**SUBJECT:** Addendum No. 3

**REFERENCE:** Invitation To Bid (ITB) for Rehabilitation of Taxiways SA & SB at IAH; Solicitation No. HJA-TXSASB-2024-020; Project No. 0646A

- I. **Replace** Document 00410 **with Revised Document 00410 – Bid Form**
- II. **Replace** Drawings Civil Section C03.01, C10.04, and C10.05 **with Revised Drawings Civil Section C03.01, C10.04, and C10.05.**
- III. **Respond** to questions.

## JOINT DETAILS I

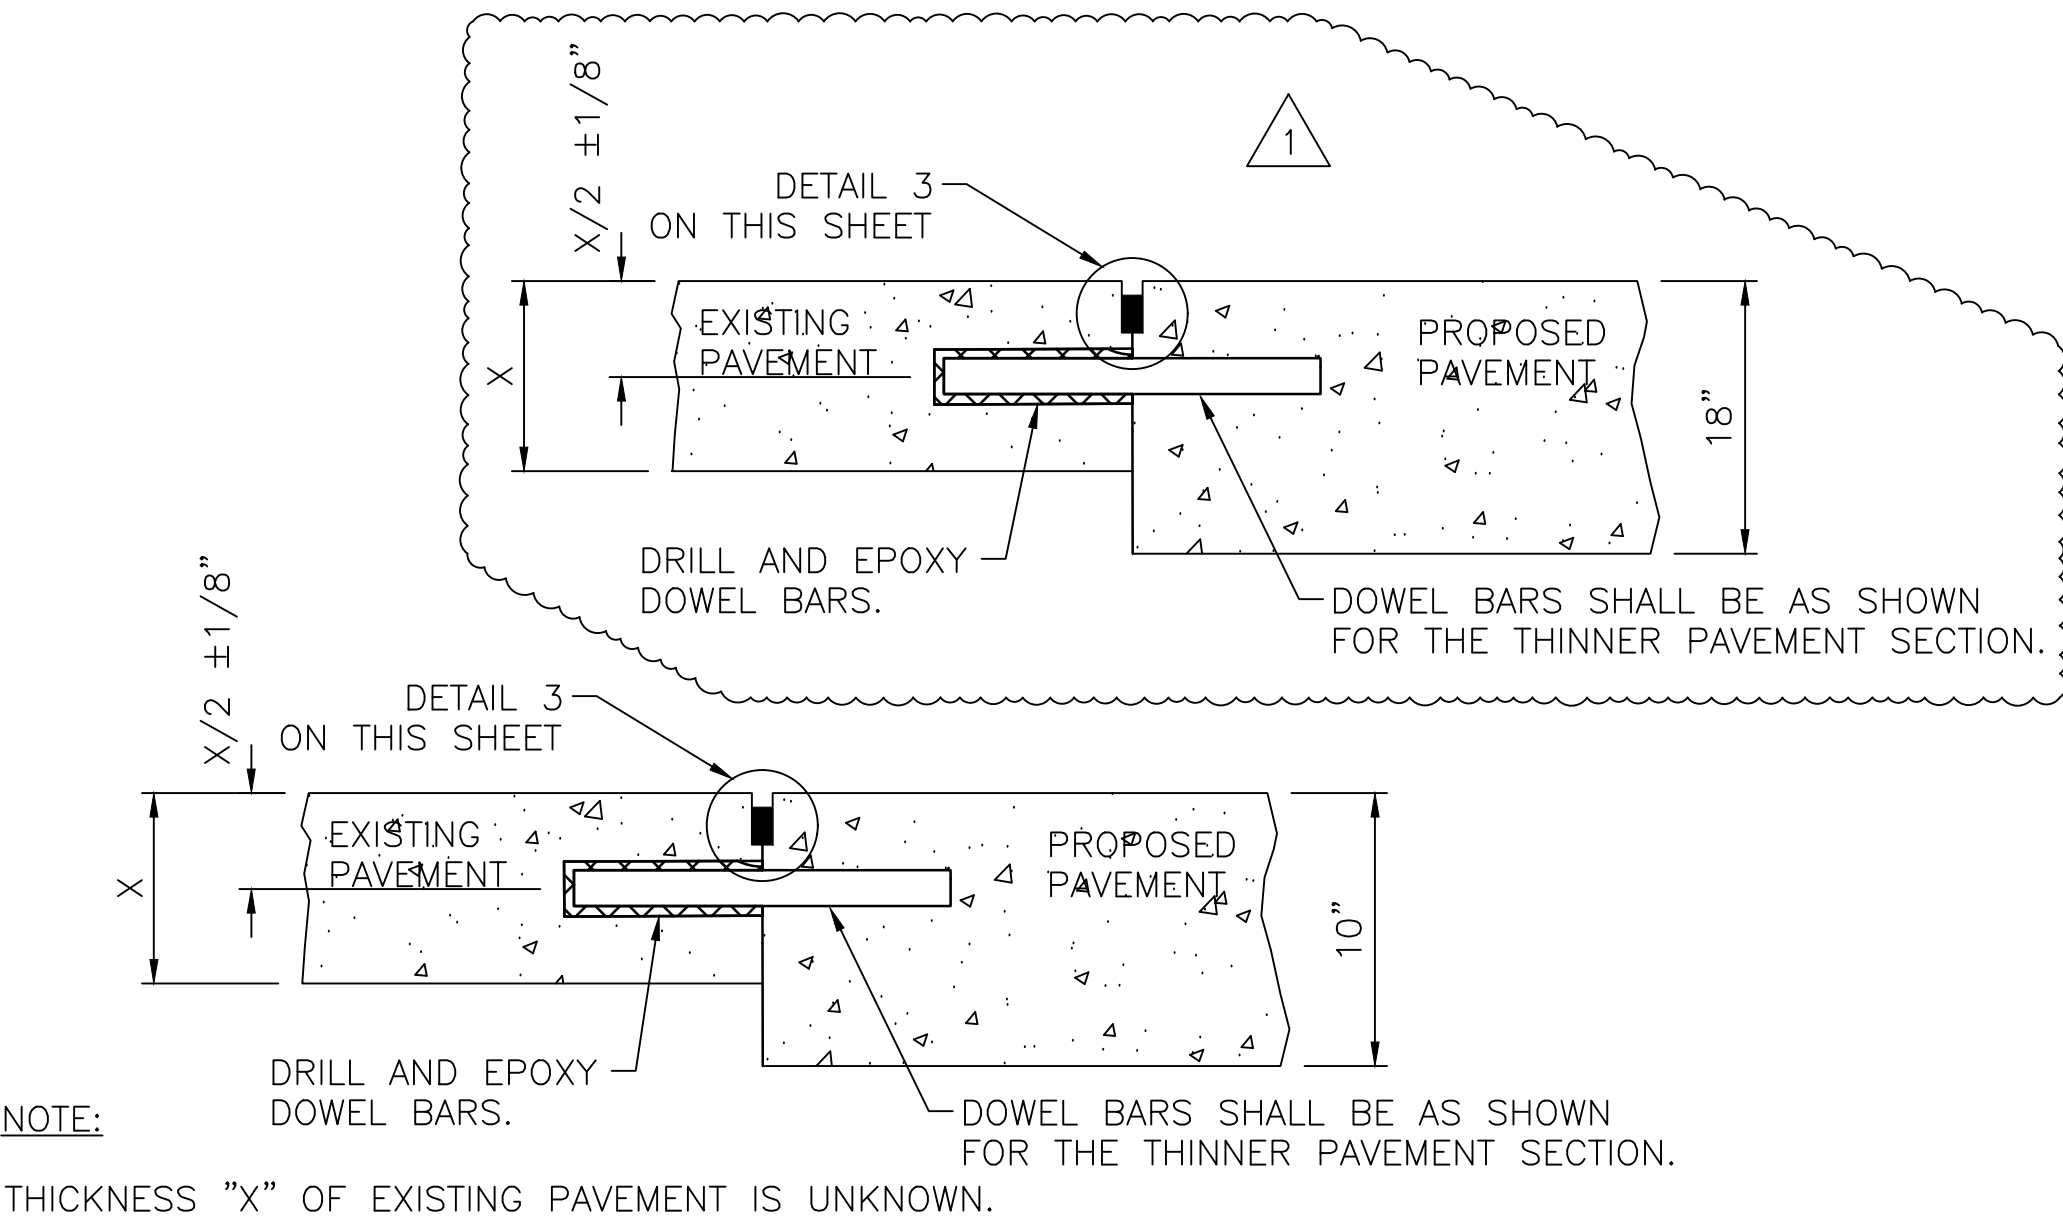
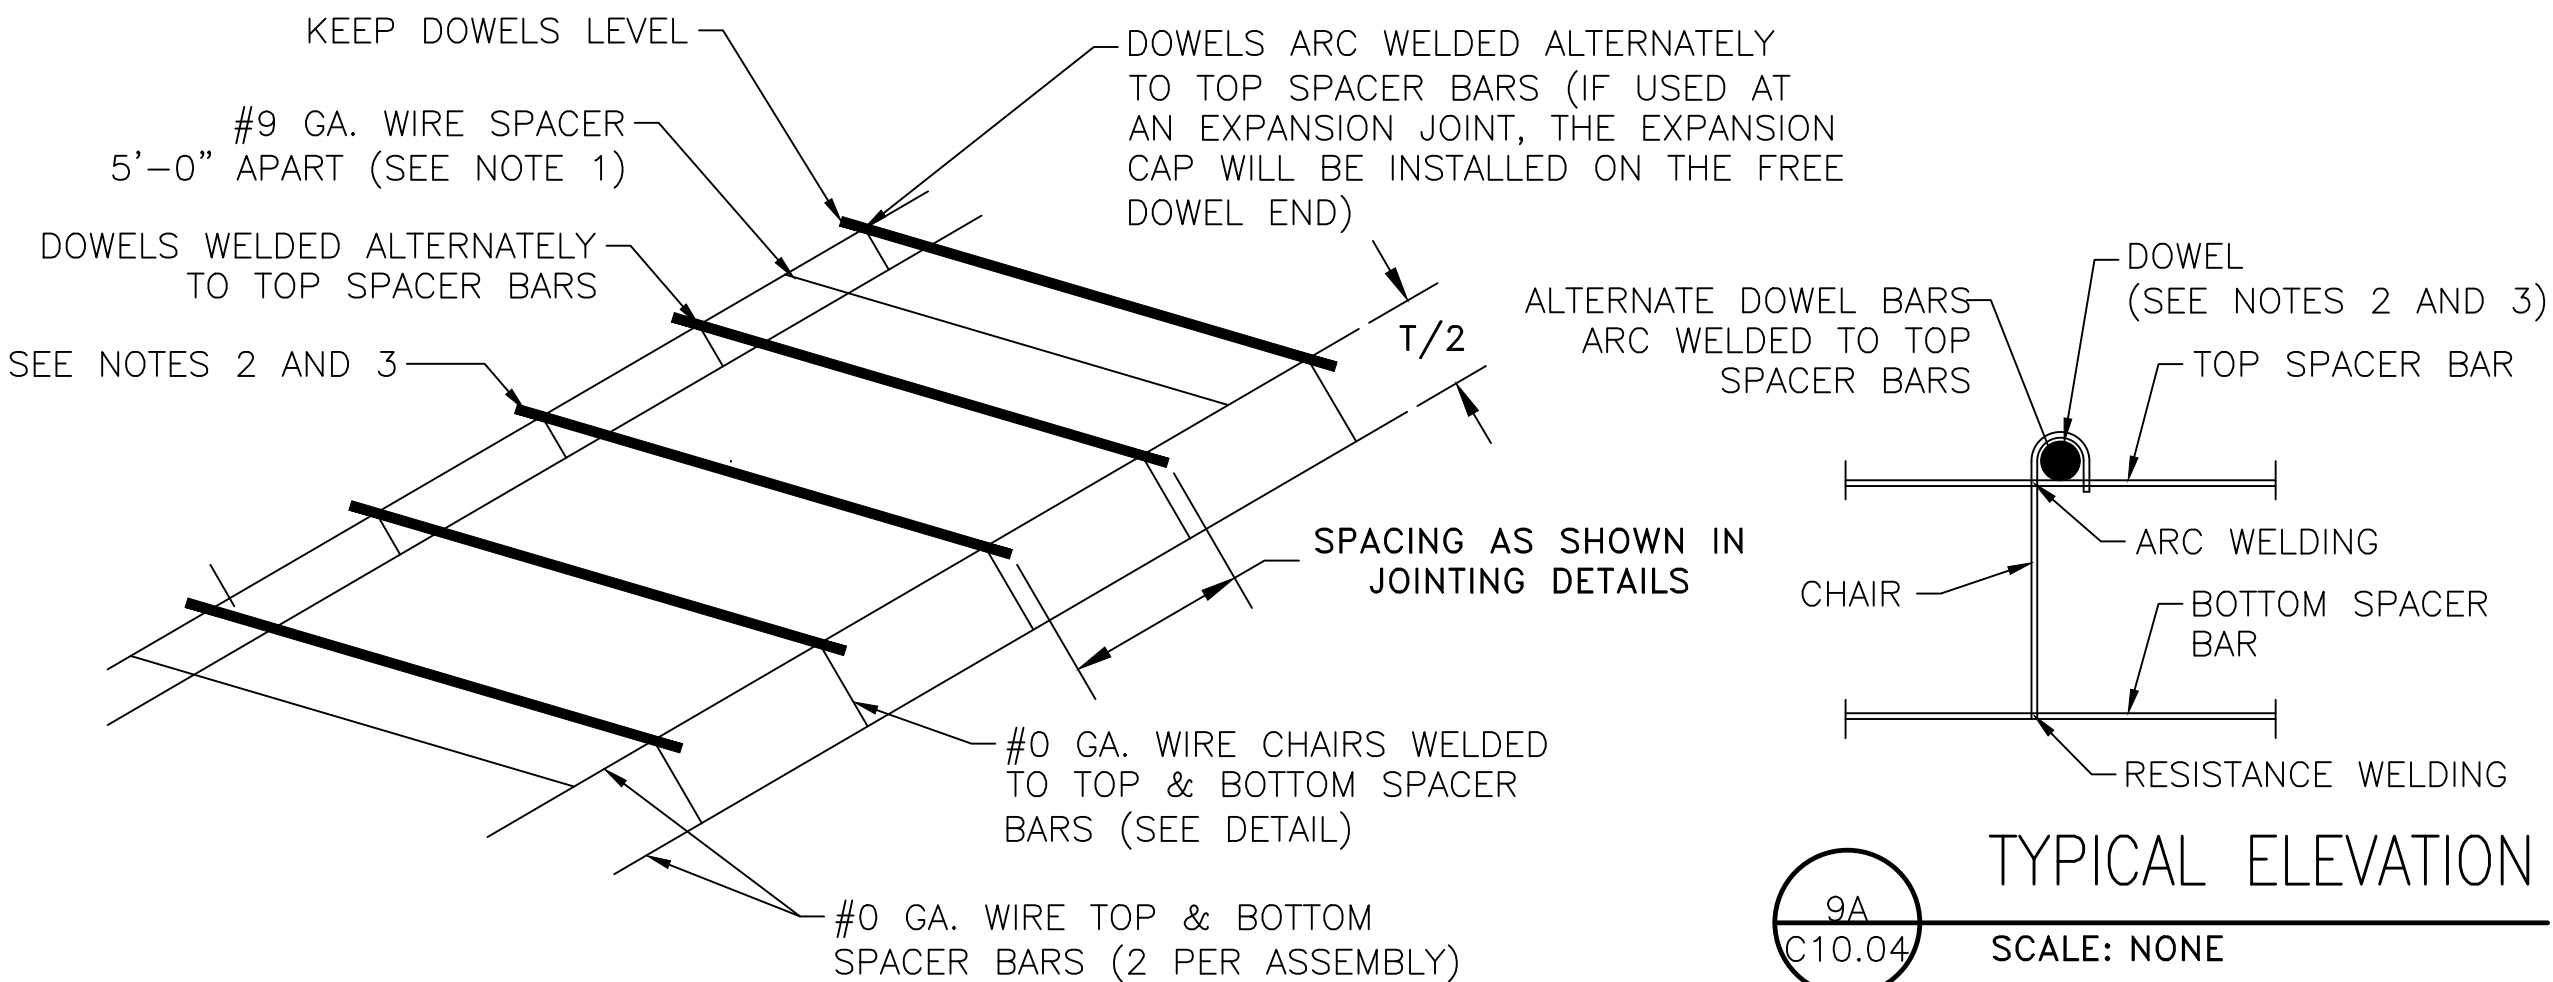
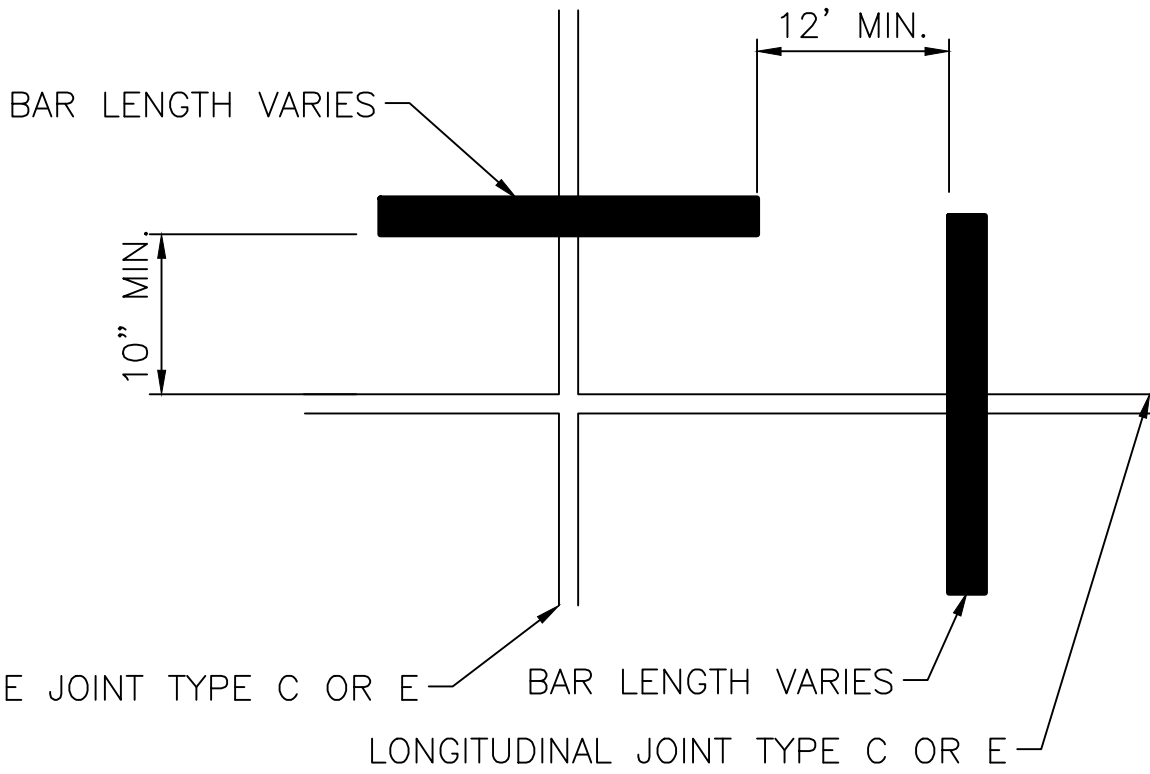
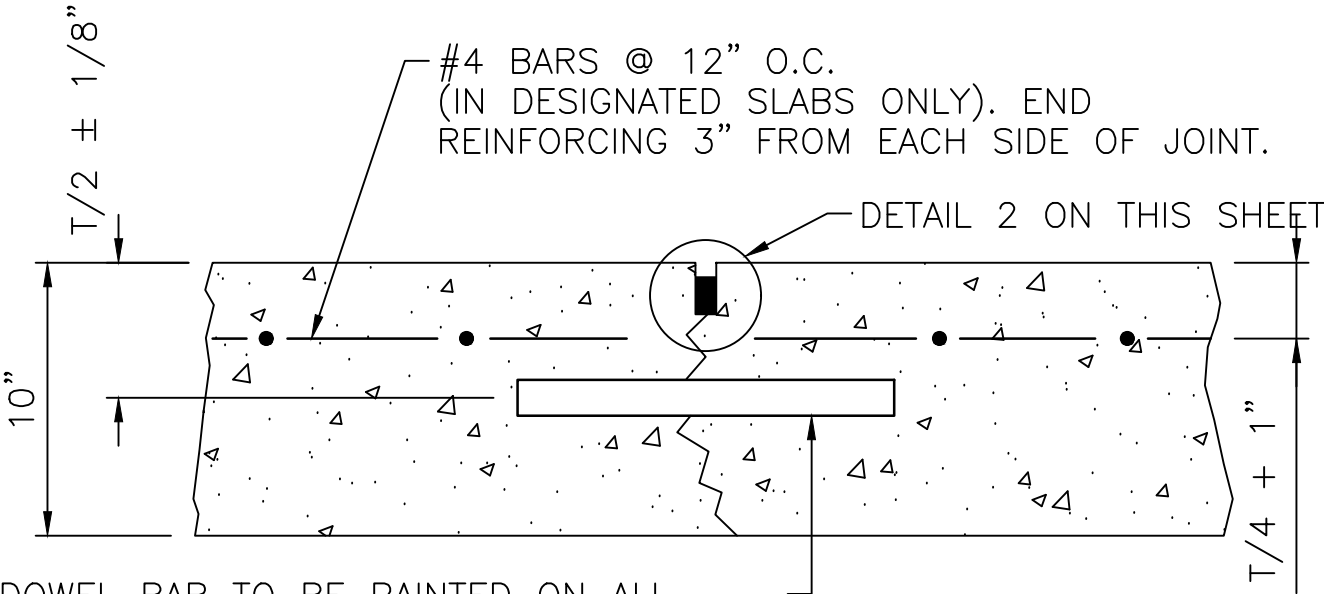
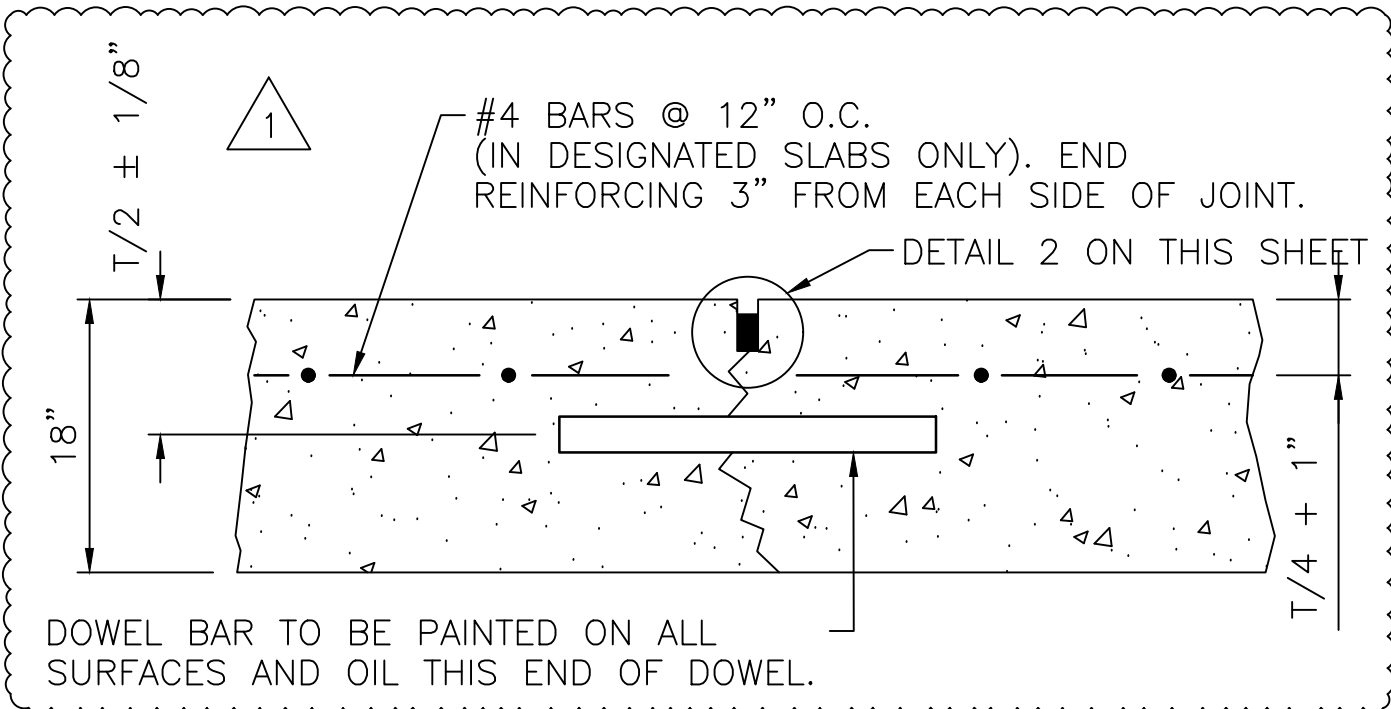
12. **Question:** Plans Details Sheet C10.04 and C10.05 only shows 15" PCC pavement while bid items is for 18" PCC Pavement.

**Response:** See revised detail on sheet C10.04.
